**Florida
Power**
CORPORATION

August 22, 1986
TRA 86-0143

Subject: Crystal River Unit 3
8/19/86 NRC-Issued License Exam

As per the current practice for examination reviews after NRC-issued operator examinations, please find enclosed our review and comments on the August 19, 1986, Reactor Operator and Senior Reactor Operator Examinations given at Crystal River Unit 3. We are including our comments and recommended action for each question under review.

Ques 2-21

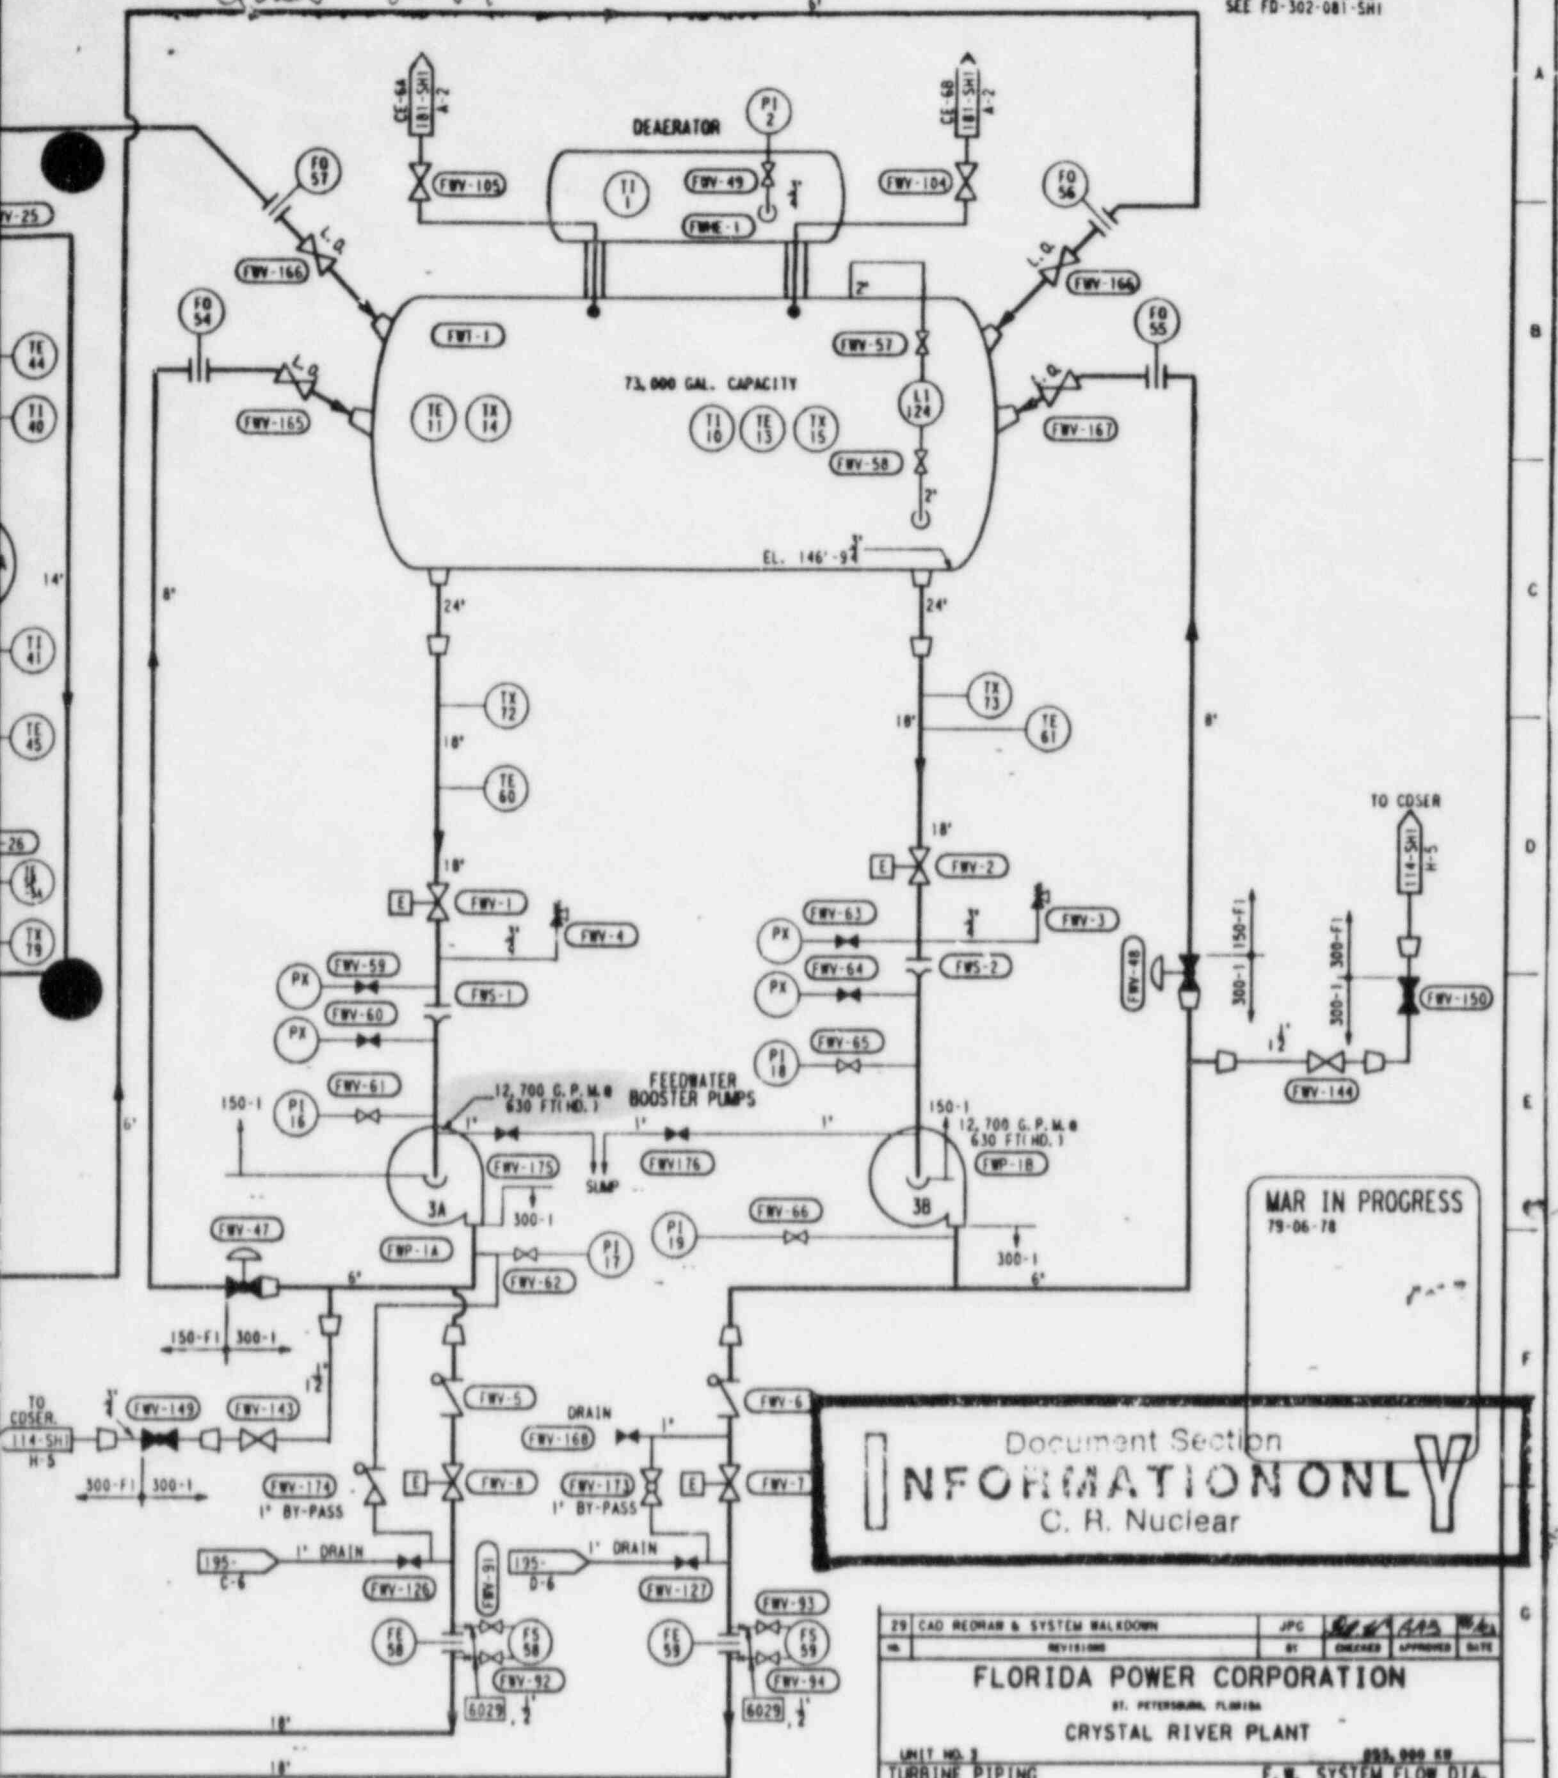
Question 2.21

Answer key is wrong. Correct answer supplied in reference 5.

RECOMMENDATION

Change answer key to 330 psig (+ or - 50)

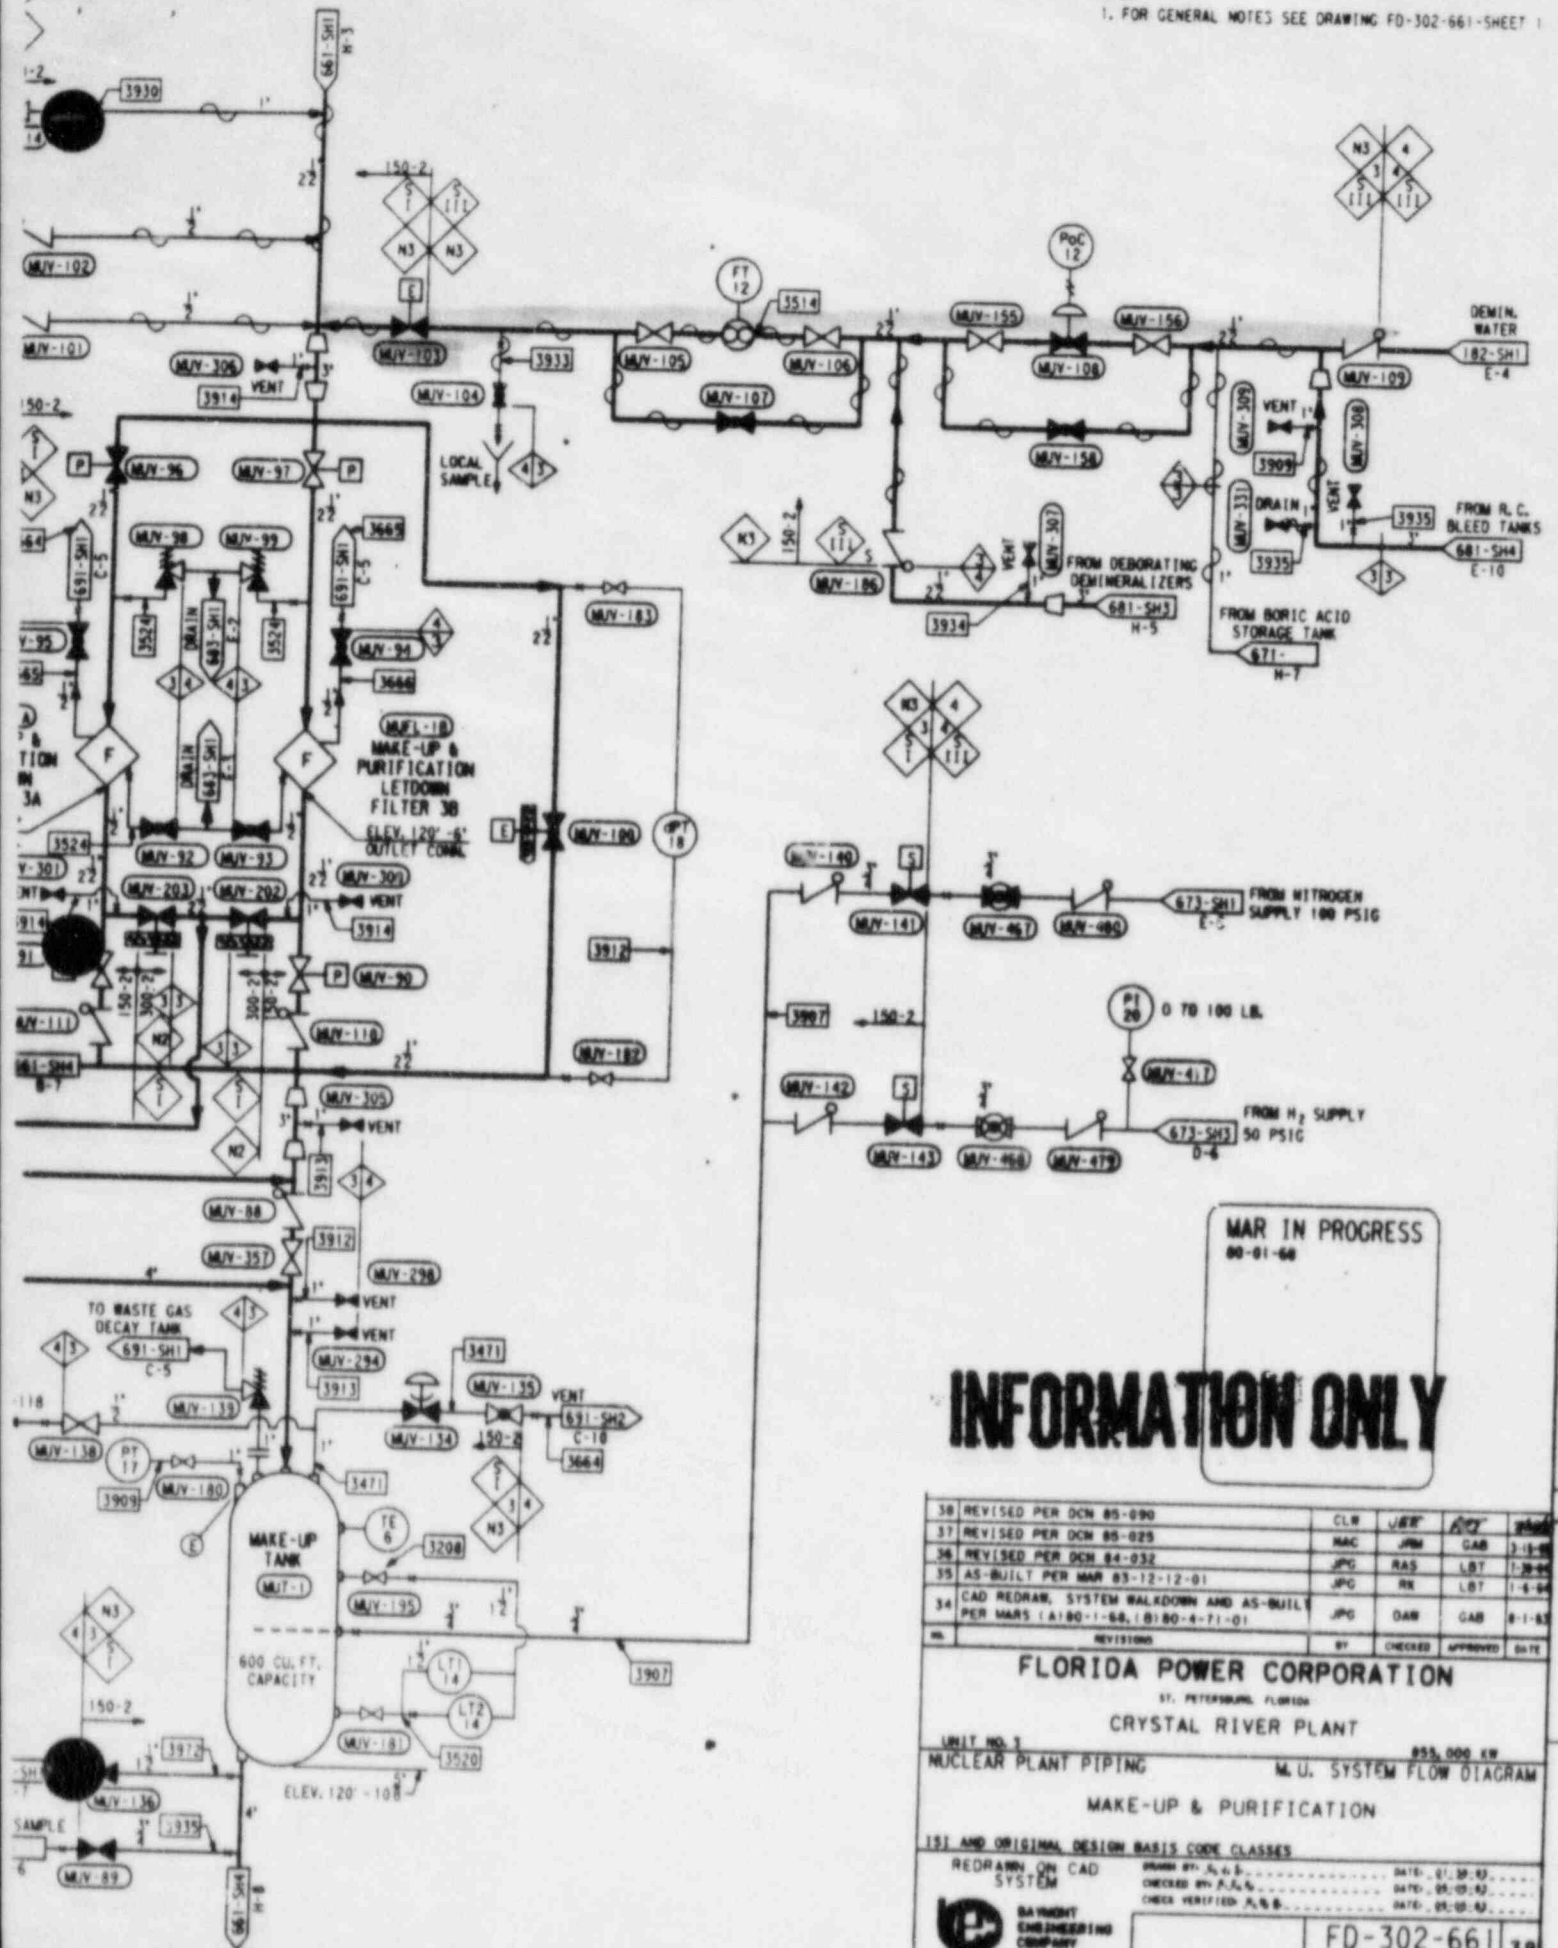
Question 4.3

To complete the requested flow path, the operator must also open MUV-103. See reference 7.

RECOMMENDATION

Add "open MUV-103" to list. Accept any five actions.

Figure 2. Relative Locations of the Products of Various Nuclear Processes

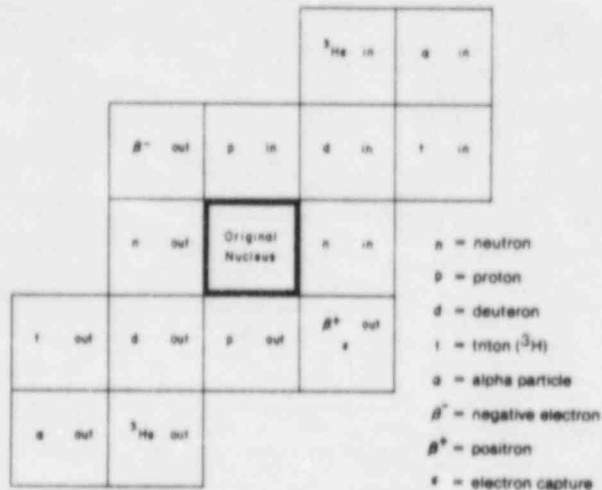
Question 5.22

Answer only considers B^- decay. Should also address decay by B^+ .

RECOMMENDATION

Accept answer for B^+ decay. See Reference 12.

Ques 6.08

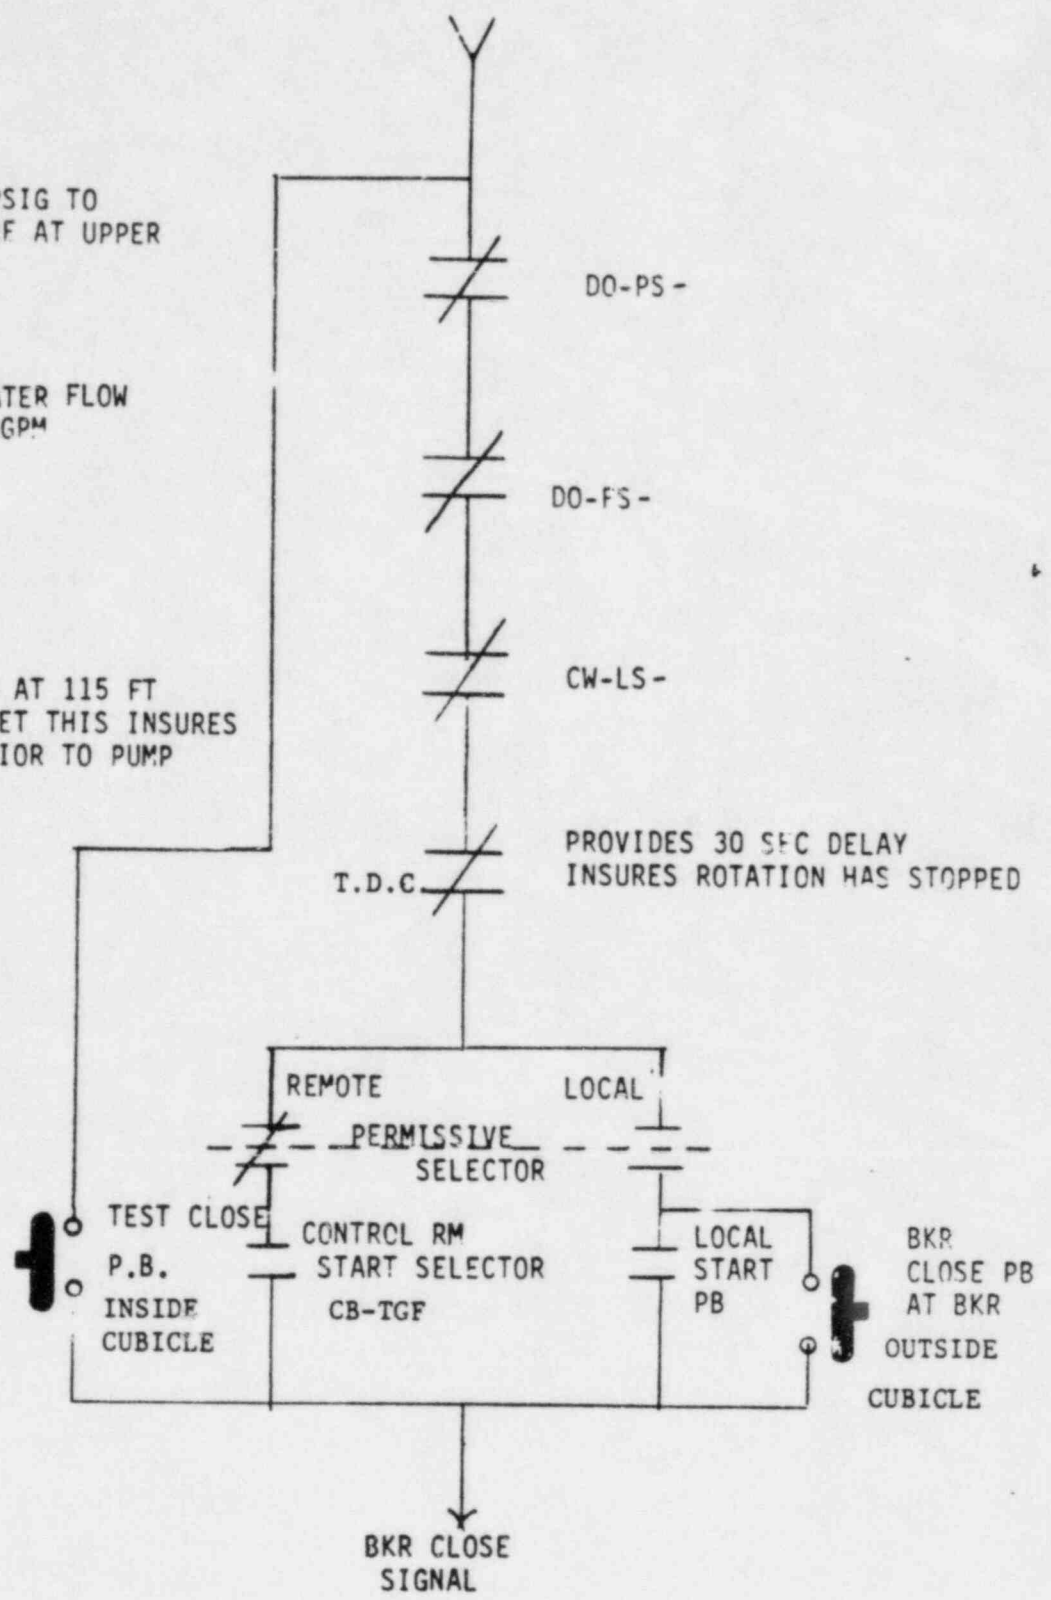
Question 6.8

Answer as written is incorrect. See reference 16.

RECOMMENDATION

Change answer per reference 16.
